**BEFORE THE PUBLIC UTILITIES COMMISSION  
OF THE STATE OF CALIFORNIA**

Rulemaking 11-10-023  
Filed October 20, 2011

**COMMENTS OF THE CONCENTRATING SOLAR POWER ALLIANCE  
ON THE PROPOSED DECISION ADOPTING LOCAL PROCUREMENT  
OBLIGATIONS FOR 2014, A FLEXIBLE CAPACITY FRAMEWORK,  
AND FURTHER REFINING THE RESOURCE ADEQUACY PROGRAM**

**Figure 1: Equivalent energy production profile of 2,970 MWh on a clear day for 200 MW CSP plant with 4 hours of storage, 275 MW CSP plant without storage, and 360 MW fixed-tilt PV plant<sup>14</sup>**

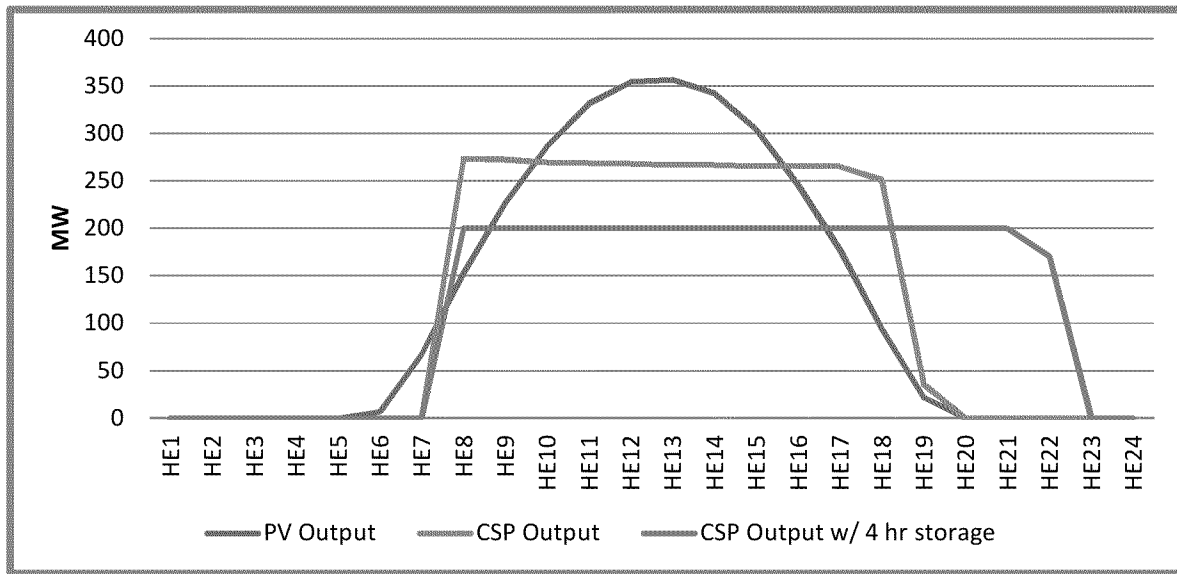
CSP with TES plant operating profiles demonstrate that these plants can (a) reduce the system need for other flexible capacity procurement by reducing variability, net load ramps and output forecast errors of the solar portfolio, and (b) provide flexible, dispatchable capabilities to meet the remaining operational needs. CSPA requests that the Commission ensure that the CAISO reflect the impact of CSP with TES plants on the annual flexibility capacity procurement
